Illinois Tollway Base Sheet Revisions

Section M	Base Sheet Drawings		
	Drawing	Modification Summary	Effective: 03-01-2025
	Overhead Sign (OHS)-Series 720		
		This set of base sheets has been converted from v8i to OpenRoads.	
	M-OHS-720	OVERHEAD SIGN STRUCTURE SPAN TYPE SUMMARY AND BILL OF MATERIAL	
		Added pay item for Drilled Shaft in Rock.	
	M-OHS-721	OVERHEAD SIGN STRUCTURE CANTILEVER TYPE SUMMARY AND BILL OF MATERIAL	
		Added pay item for Drilled Shaft in Rock.	
	M-OHS-722	OVERHEAD SIGN STRUCTURE ENTRANCE MONOTUBE TYPE (STEEL) MAINLINE RAMP SUMMARY AND BILL OF MATERIAL	
		Added pay item for Drilled Shaft in Rock.	
	M-OHS-723	OVERHEAD SIGN STRUCTURE EXIT MONOTUBE TYPE (STEEL) MAINLINE RAMP SUMMARY AND BILL OF MATERIAL	
		Added pay item for Drilled Shaft in Rock.	
	M-OHS-724	OVERHEAD SIGN STRUCTURE BUTTERFLY TYPE SUMMARY AND BILL OF MATERIAL	
		Added pay item for Drilled Shaft in Rock.	
	M-OHS-725	OVERHEAD SIGN STRUCTURE ENTRANCE MONOTUBE TYPE (STEEL) AET RAMP SUMMARY AND BILL OF MATERIAL

Illinois Tollway Base Sheet Revisions

VERSION: 2025-03	BASE SHEET: M-OHS-725	SHEET: 1 OF 1
----------------------------	---------------------------------	-------------------------

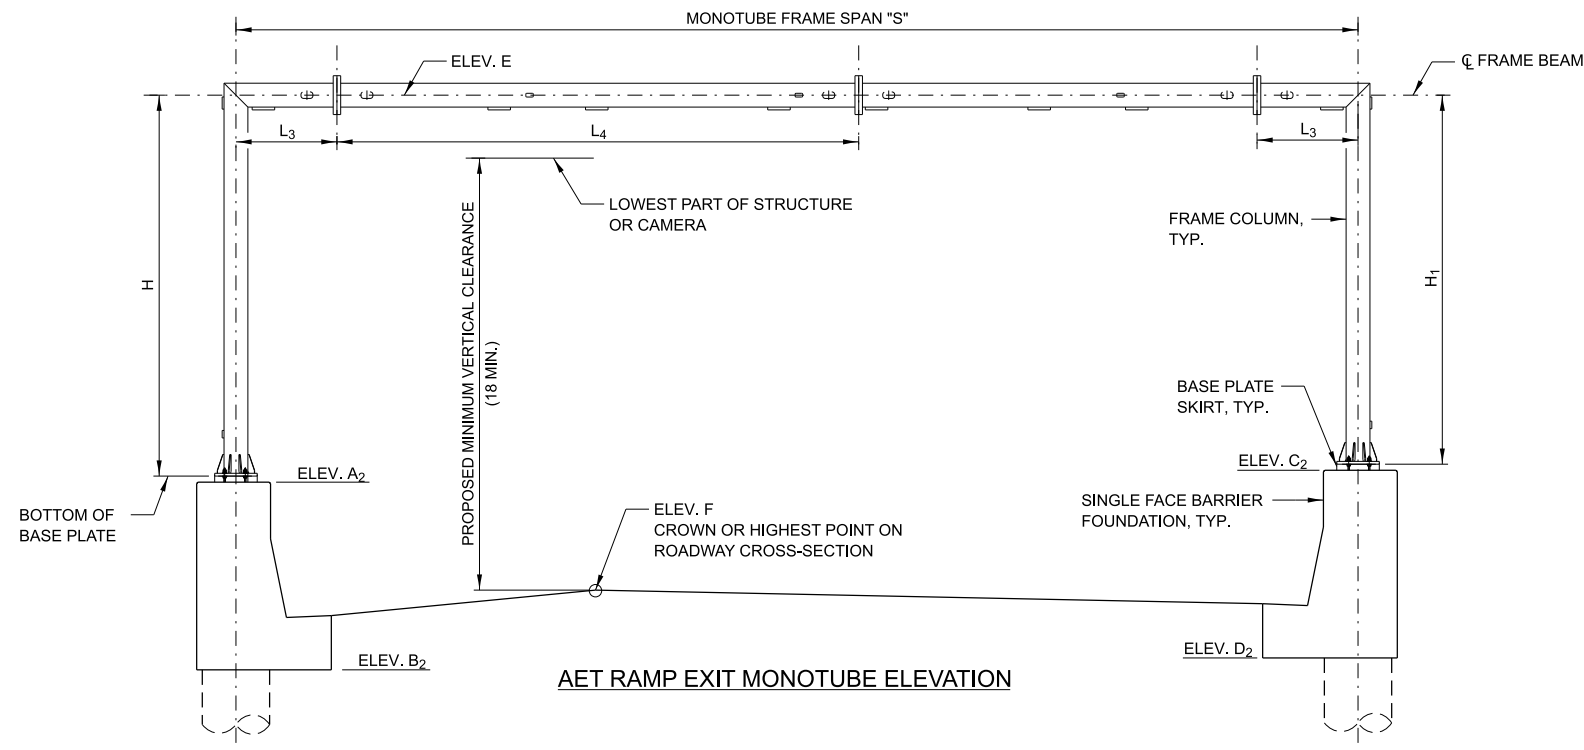
Added pay item for Drilled Shaft in Rock. Updated elevations to match with F15 standard.	
	M-OHS-726	OVERHEAD SIGN STRUCTURE EXIT MONOTUBE TYPE (STEEL) AET RAMP SUMMARY AND BILL OF MATERIAL	
		Added pay item for Drilled Shaft in Rock. Updated elevations to match with F15 standard.	
	 M-OHS-727	OVERHEAD SIGN STRUCTURE MONOTUBE TYPE (STEEL) CASH-IPO RAMP SUMMARY AND BILL OF MATERIAL	
	M-OHS-728	OVERHEAD SIGN STRUCTURE SPAN TYPE SUMMARY AND BILL OF MATERIAL	
		Added pay item for Drilled Shaft in Rock.	
	M-OHS-729	OVERHEAD SIGN STRUCTURE ITS GANTRY FRAME (STEEL) SINGLE SPAN STRUCTURE DETAILS

* INCLUDE THIS PAY ITEM IF ROCK IS ENCOUNTERED.
QUANTITY OF DRILLED SHAFT IN ROCK IS NOT
INCLUDED IN THE PAY ITEM JS734F10.

**OVERHEAD SIGN STRUCTURE
ITS GANTRY FRAME (STEEL)
SINGLE SPAN STRUCTURE
DETAILS**

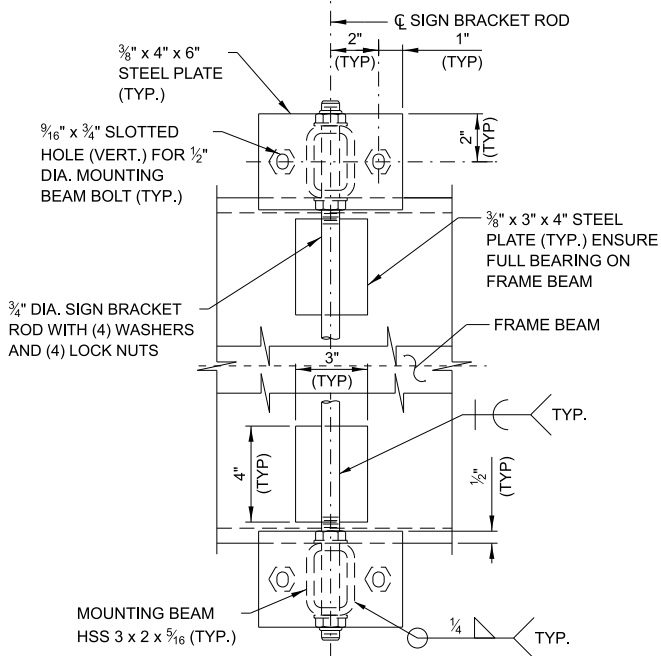
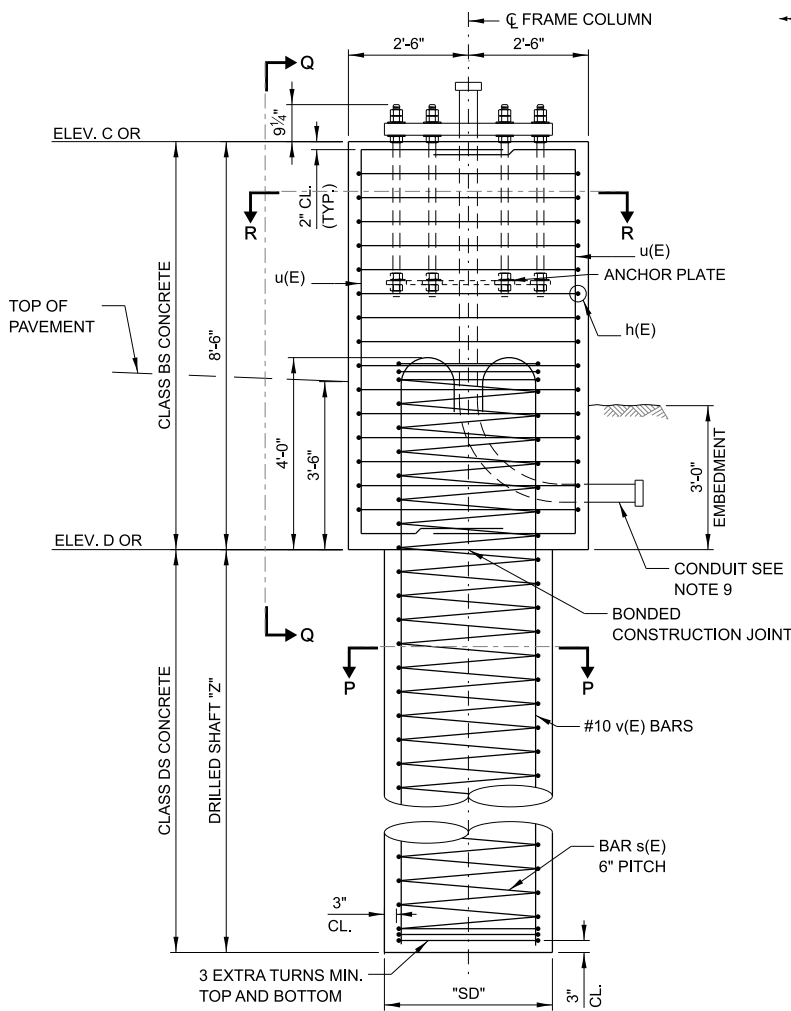
Sheet 1	Added pay item for Drilled Shaft in Rock.	
	Sheet 5	Revised notes to ensure that stainless steel locknut is paired with stainless steel threaded rod and galvanized locknut is paired with galvanized threaded rod.	
	M-OHS-730	OVERHEAD SIGN STRUCTURE ITS GANTRY FRAME (STEEL) TWO-SPAN STRUCTURE DETAILS

8. STAINLESS STEEL NUTS/LOCKNUTS SHALL BE USED WITH STAINLESS BOLTS AND RODS AND GALVANIZED NUTS/LOCKNUTS SHALL BE USED WITH GALVANIZED THREADED BOLTS AND RODS.
